Notice of Decision

APPLICATIONS: Project No. PRJ12-00043
File No. AAS16-00002

PROJECT NAME: Gateway Senior Housing Administrative Adjustment of Circulation Facilities Standards

Fig. 1. North Section of Neighborhood Street showing missing sidewalk

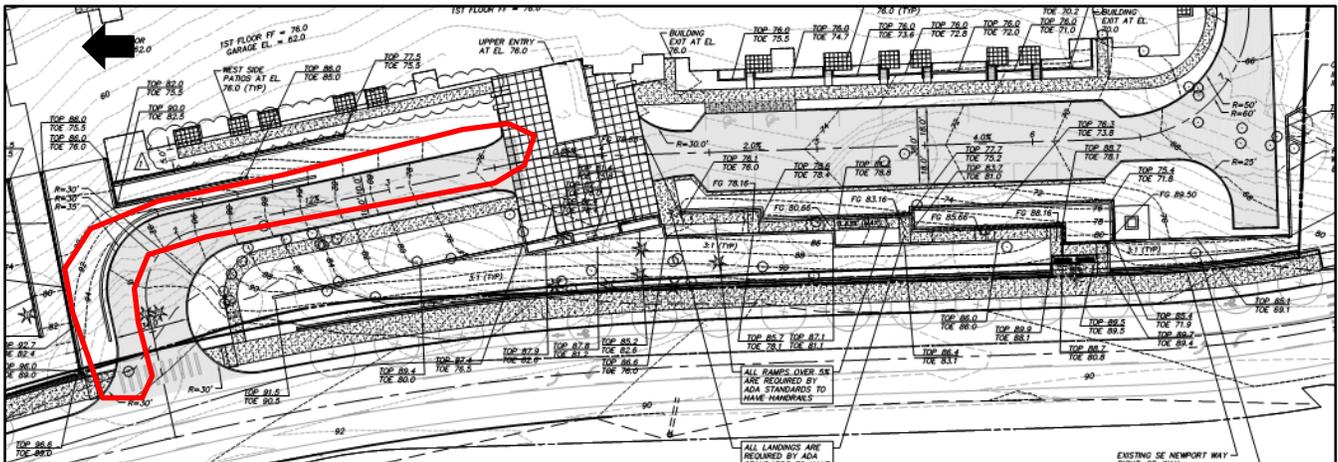
Note: The original application for an AAS included the north section at Newport Way, where the eastern sidewalk is missing or provided but not adjacent to the travel lane and is separated by a large landscaped area (see Fig. 1). From Newport Way, the pedestrian can only use one sidewalk and will need to cross the pedestrian plaza to get to the main entry of the building. During the review period, Staff received comments from the public and the Development Commission suggesting that the grade along the northern part of the property at Newport Way be further evaluated to incorporate a sidewalk with stairs. This sidewalk need not be the primary pedestrian access to the site, since the primary access, which complies with federal accessibility standards, is provided at the southern end of the property frontage, with a sidewalk ramp that leads to the front entrance of the

building from Newport Way. Sidewalks provided along the vehicular access drive could be used by pedestrians coming from the northwest end of Newport Way and serves as secondary access, consistent with the intent of the CIDDs, which require multiple access to properties from adjacent properties. The Applicant has since revised the site plan to include a sidewalk so this request for adjustment of standards is no longer being pursued (see Attachment 2, Revised Site Plan).

Fig. 2. Missing Sidewalk (red circle) at South Section of Neighborhood Street

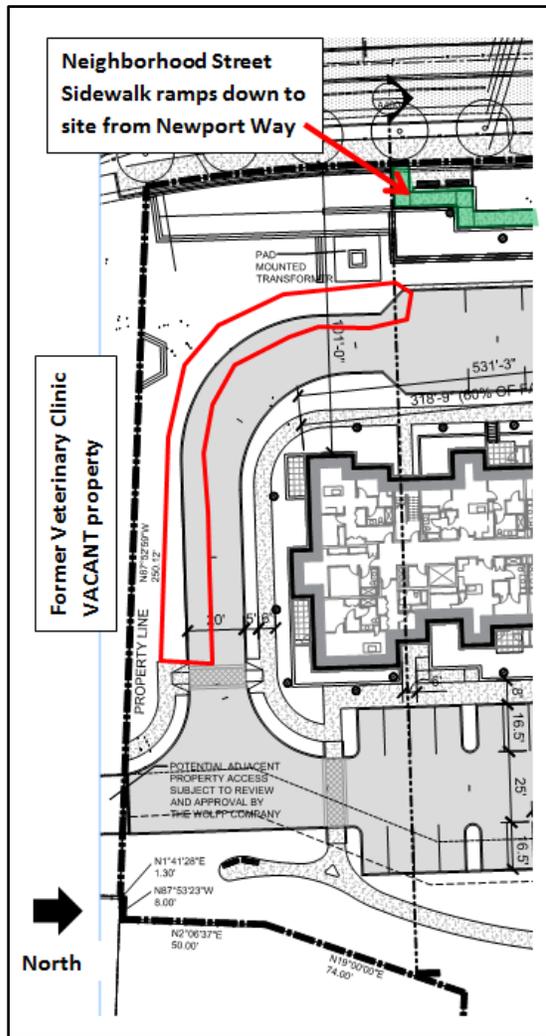
Adjustment 1

The sidewalk on the south side of the Neighborhood Street at the south end of the site is not provided (see Fig. 2).

Fig. 3. Sidewalk Ramp (green) at South Section of Neighborhood Street

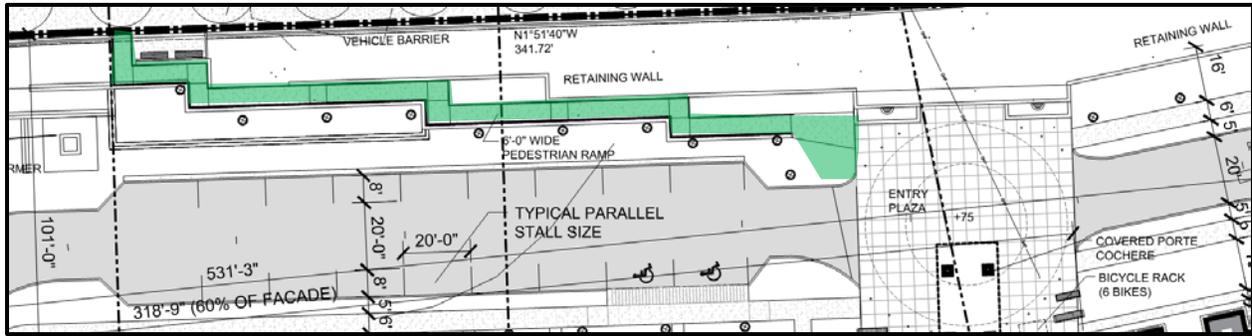
Adjustment 2

At the south section, the Neighborhood Street is a sidewalk ramp that connects the multi-use sidewalk/bike path on Newport Way to the main entrance of the building at the lower grade of the site. The sidewalk is separated by the grade changes and a wider planter area from the on-street parking of the Neighborhood Street. (See Fig. 3). The site grading provides terracing with retaining walls to address the significant grade change from the property line on Newport Way and the Neighborhood Street grade. In doing so, the sidewalk connecting from Newport Way to the main entrance is incorporated into the terraced landscape area and provided with ramps that ensure accessibility for non-motorized wheeled transport such as wheelchairs and bicycles. A 2-foot wide paved strip is provided next to the parallel parking spaces to provide space for passenger side access to cars.

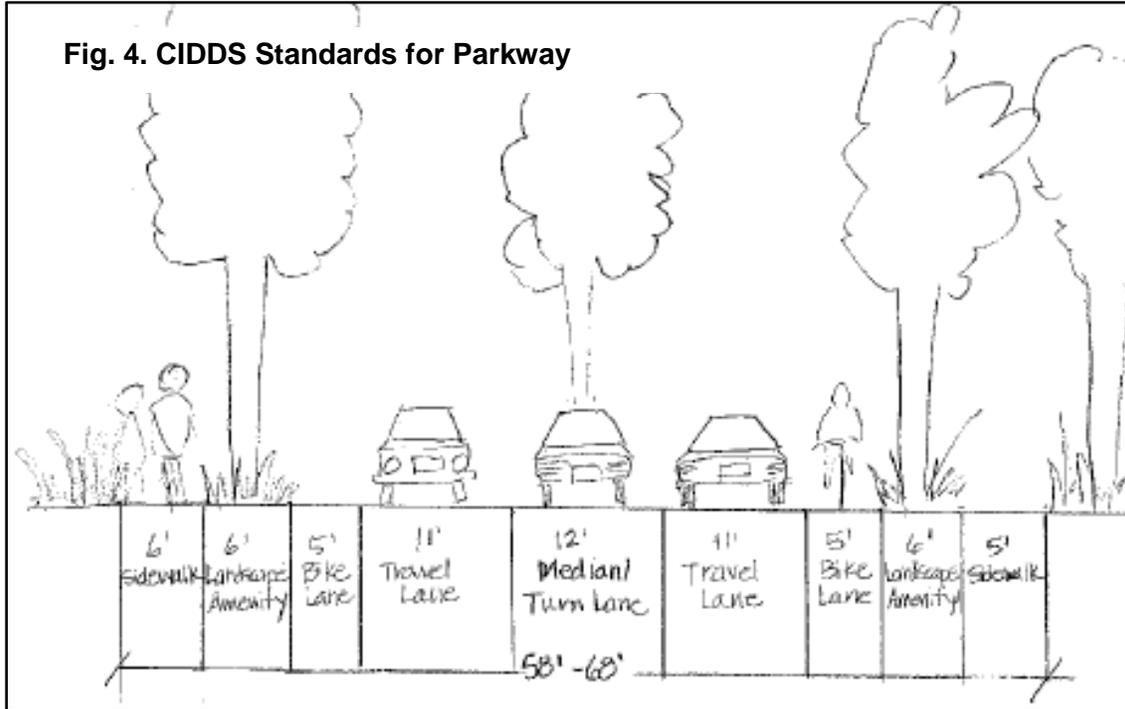
- d. **Sufficient Reason:** The adjustment of standards takes into consideration the steep slopes (see Fig. 6.2.A) and balances the need to provide pedestrian-friendly facilities with the amount of grading required. The modification of the sidewalk location takes into consideration the “desire” paths of pedestrians. The ramped walkway from Newport Way that serves as a sidewalk was also a pragmatic approach to meeting ADA-compliant sidewalks and the limitation of the site topography. However, this sidewalk would be redundant and ill-used, since there are no front doors or buildings along this side of the street. The “desire path” of pedestrians along this section of the Neighborhood Street is

to walk towards the lobby and main entry of the building. They are more likely to walk across the vehicular travel lane than to use a sidewalk, if one was provided next to the parking spaces. The other “desired path” is from the crosswalk at Newport and Pine Cone to the building entry. As such, the ramped walkway is the most appropriate pedestrian facility that serves the function of a sidewalk.

The sidewalk is not provided at the south side of the Neighborhood Street at the southern perimeter of the property because this side of the property has no active uses and it is not feasible to connect the sidewalk to the sidewalk ramp connecting to Newport Way that was described above. The sidewalk resumes at the pedestrian crossing and will be connected to a future sidewalk on the adjacent property.
